PERMIT

SEWAGE DISPOSAL SYSTEM

HOWARD COUNTY HEALTH DEPARTMENT

SUBDIVISION Holly Hills LOT 8 ROAD 3327 Sang Road

(ROAD IMPROVEMENT ONLY)

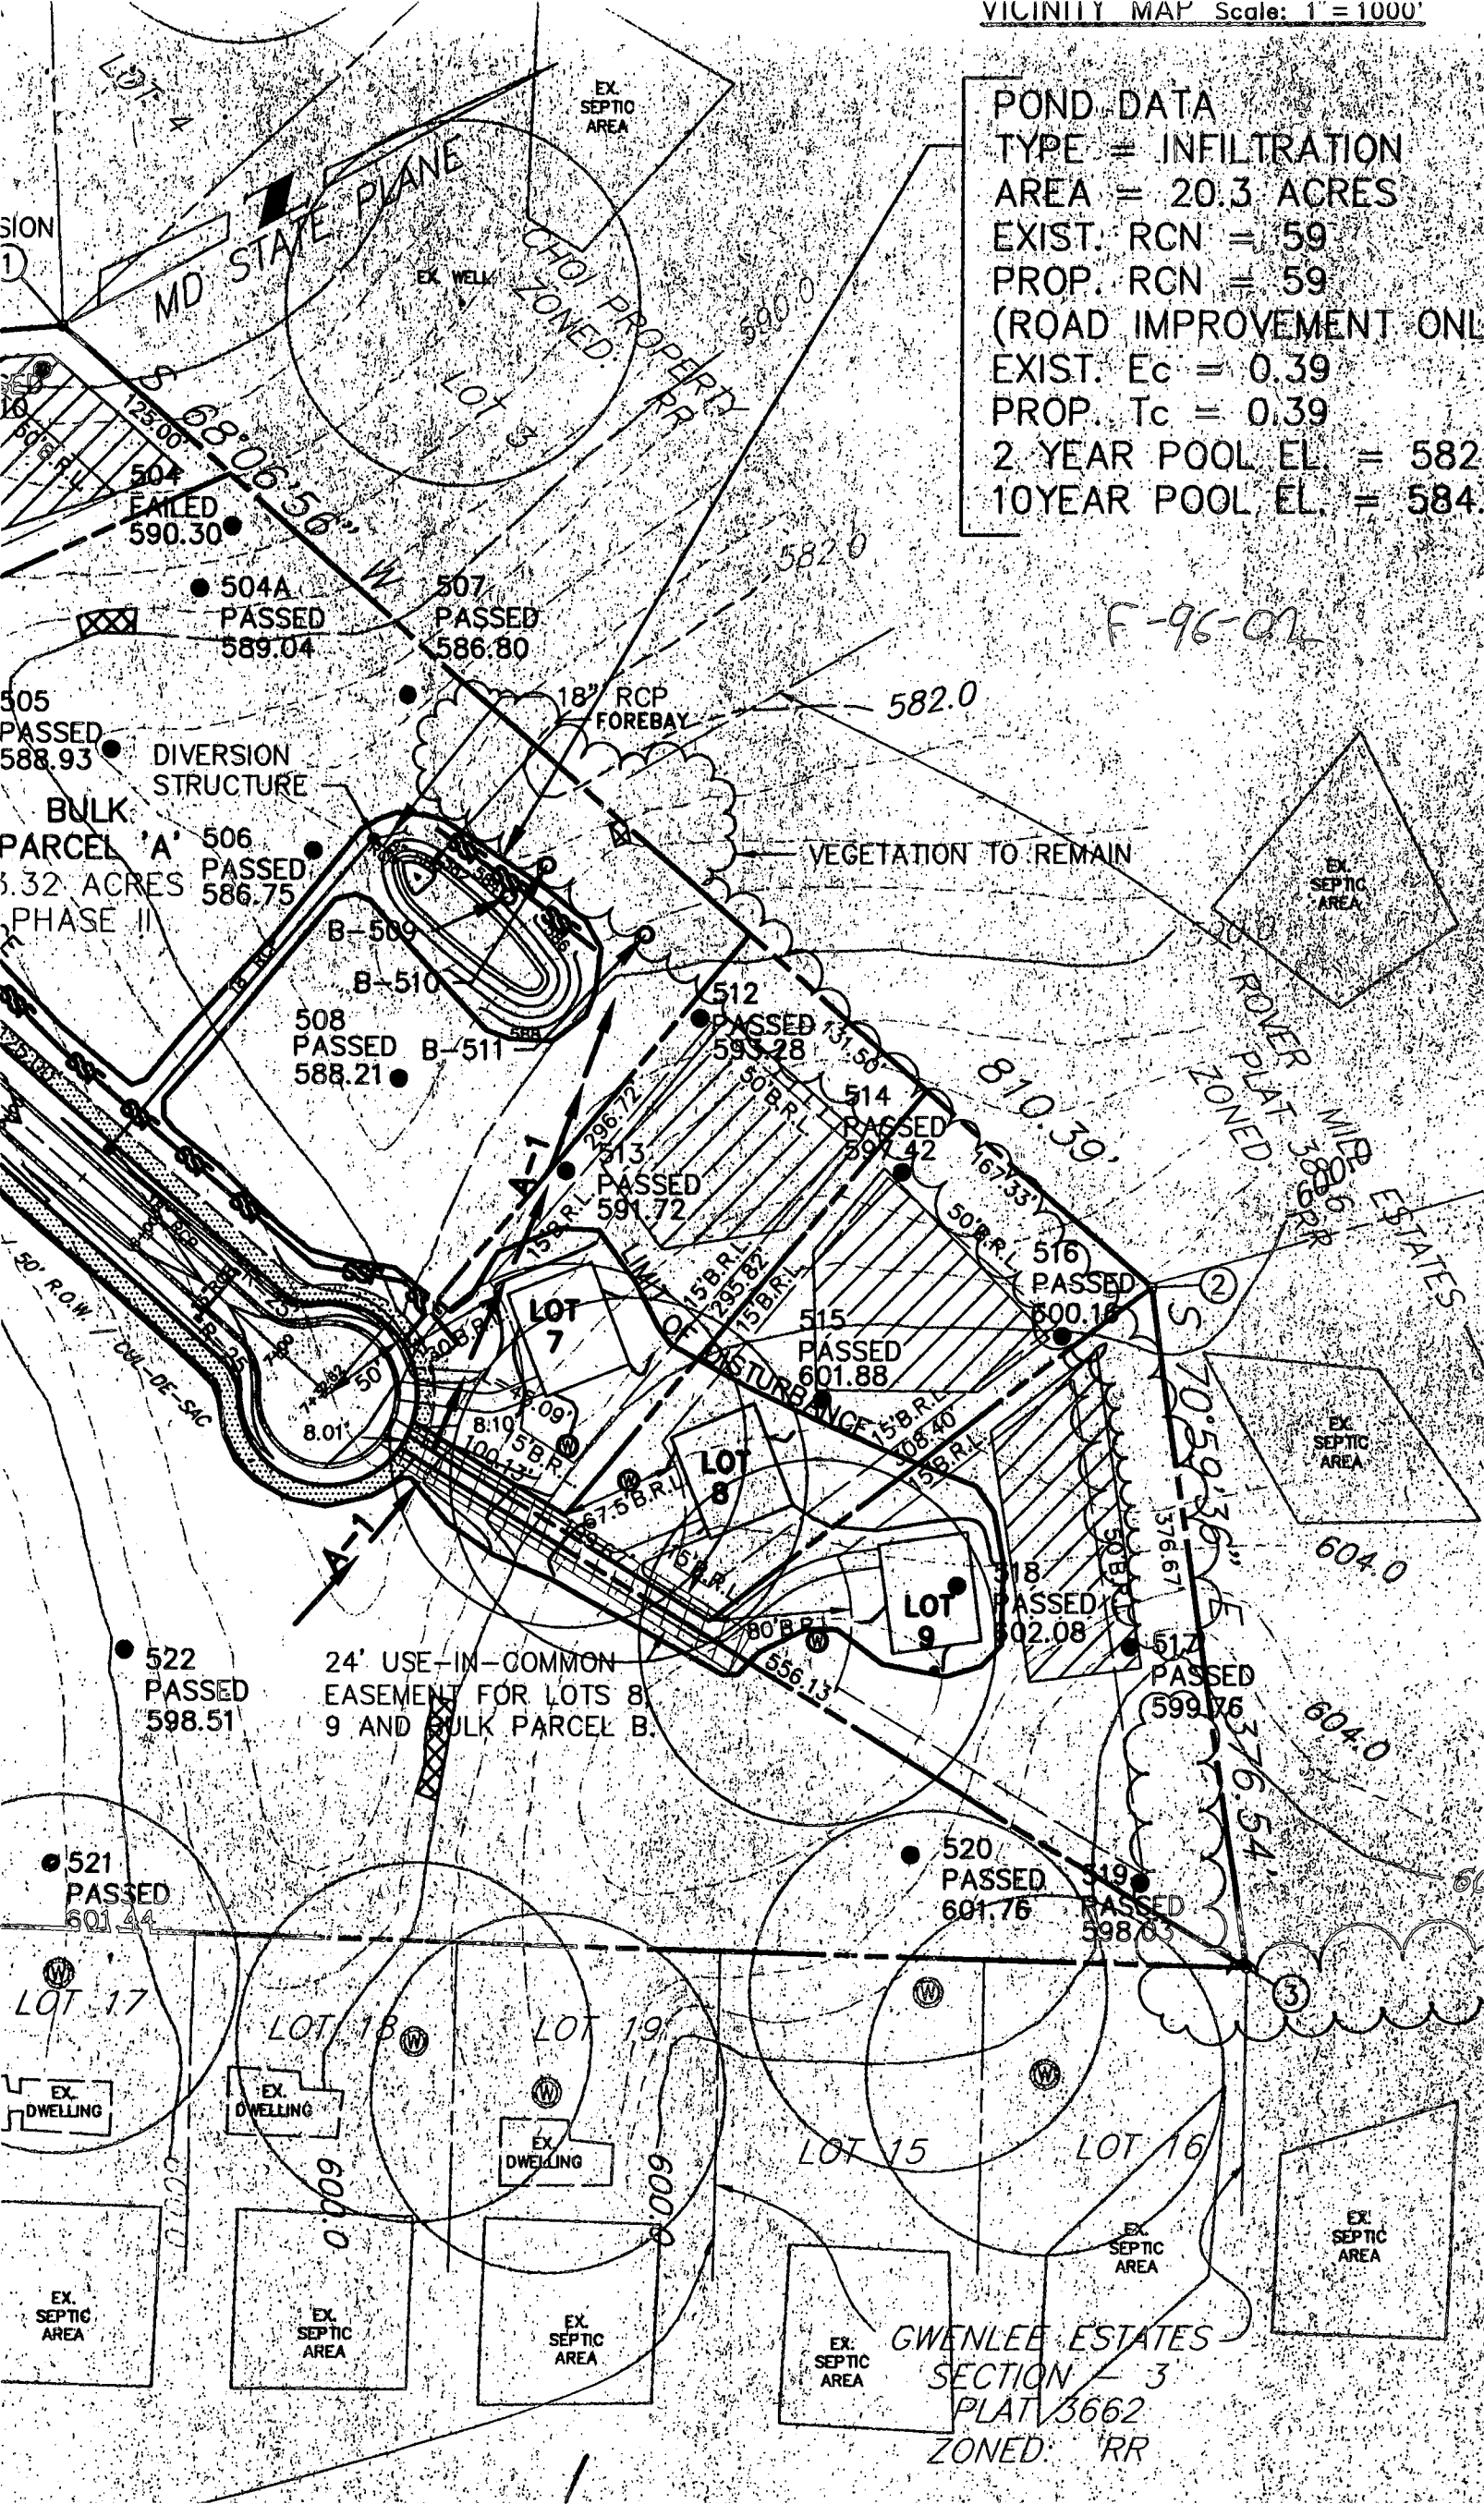
5-9-97
 JOHN MILDENBERG
 WILL BE SUBMITTING
 A REVISED
 PLAN SOON
 NOTES BELOW
 DISCUSSED
 100' TO WELL MIN. 1
 50' TRENCHES MIN
 SYSTEM FIRST
 IE GRADED
 AS
 LOT 9

REVISION TO ACCOMMODATE WALK OUT BASEMENT THAT IS TOO DEEP
 JOHN MILDENBERG TO SUBMIT LOCATION FOR WELL ON LOT 9

PROPOSED GRADING OK, ADVISE INSTALLING SEPTIC SYSTEM EAST ADJUSTING
 SOA TO BETTER MATCH EXISTING SITE CONDITIONS IF IT IS RECONFIGURED
 MINIMAL RESTRICTIONS AS TO SOA RECONFIGURATION, REARWARD OK - WILL HAVE TO
 CUT TREES FOR REPAIR, IF SOA IS MOVED FORWARD TOWARDS THE RIGHT
 FRONT CORNER OF LOT ~~THE~~ POTENTIAL ADDITION AREA WILL BE LOST.
 - NEED REVISED PLAN ~~BY~~

LOT 8

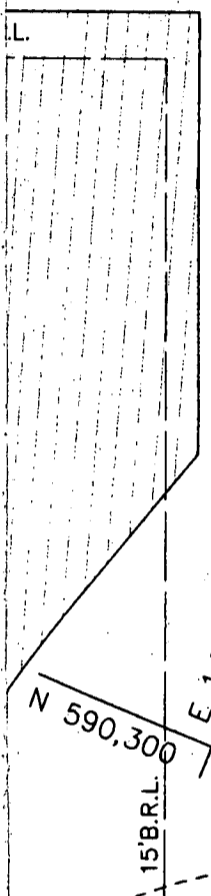
5/27/97
LP TANK OK
AS SHOWN

LOT 8 SITE PLAN

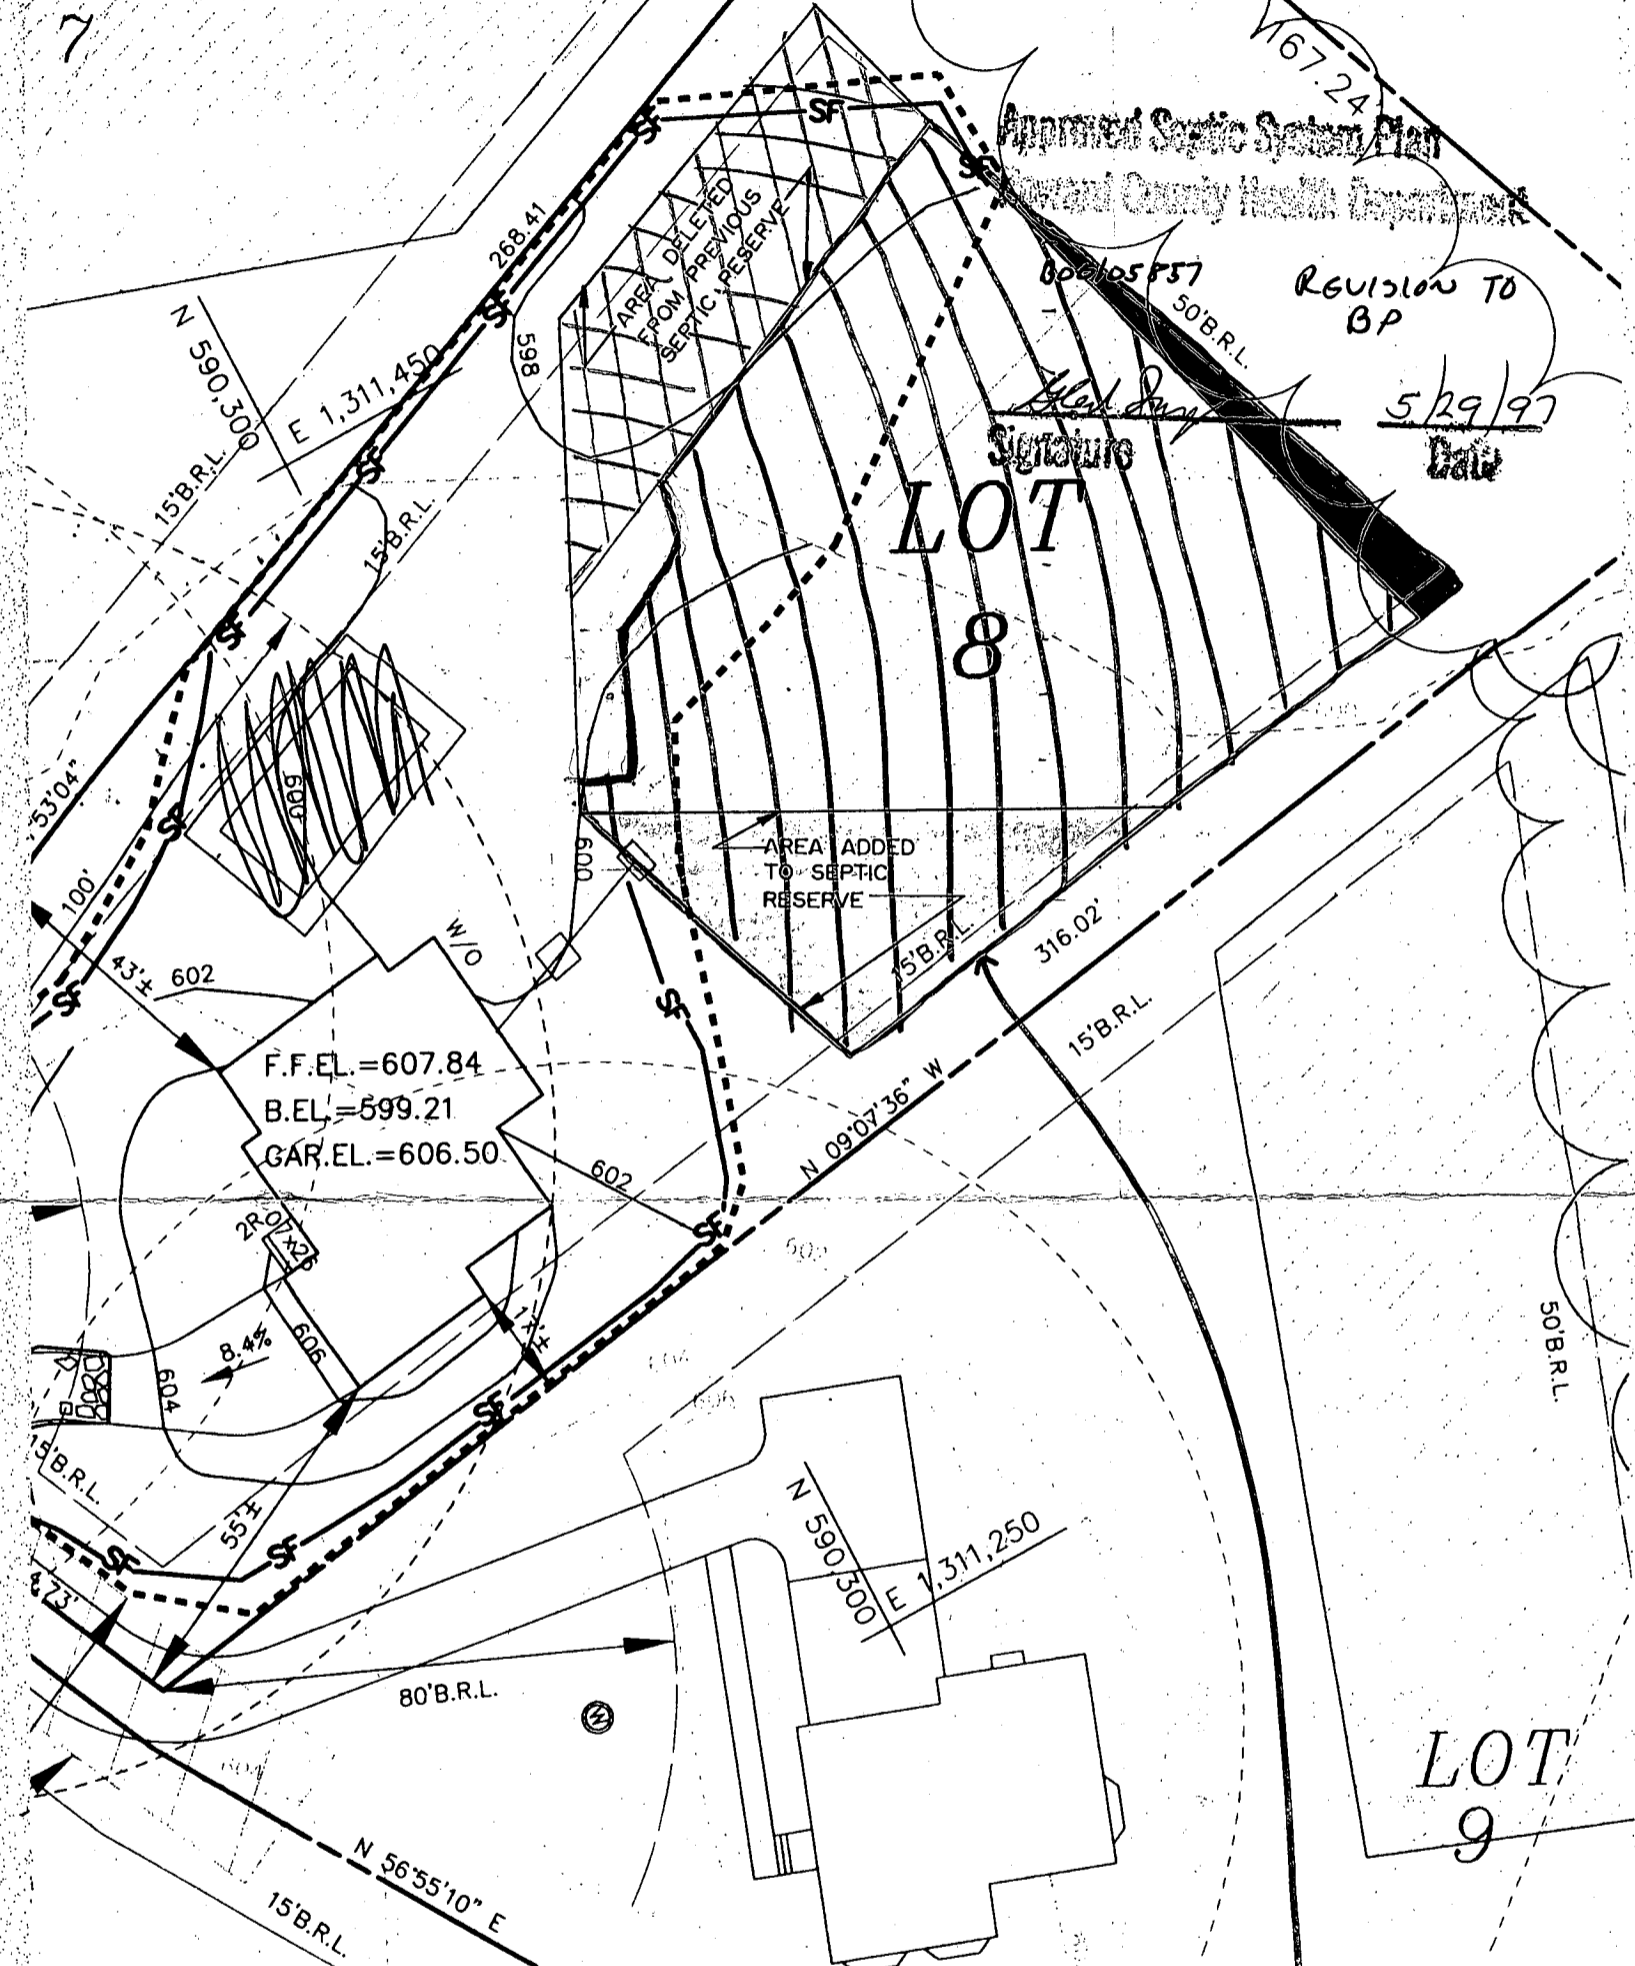
- 10/16/00
Modified septic easement as of 10/16/00
- Area deleted for proposed pool 20' setback
- Area added on 10/16/00
